Product Change Notice

The Eaton PowerStor XB and XV Series supercapacitors are receiving a visible change. This change involves adding a groove around the circumference at the center of the length, as shown in the illustration below.

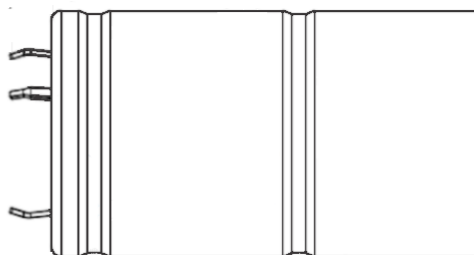
This groove enhances mechanical stability to the electrode structure inside the can and is part of our continuous improvement efforts.

There is no change to the form, fit, electrical properties, or function of these supercapacitors.
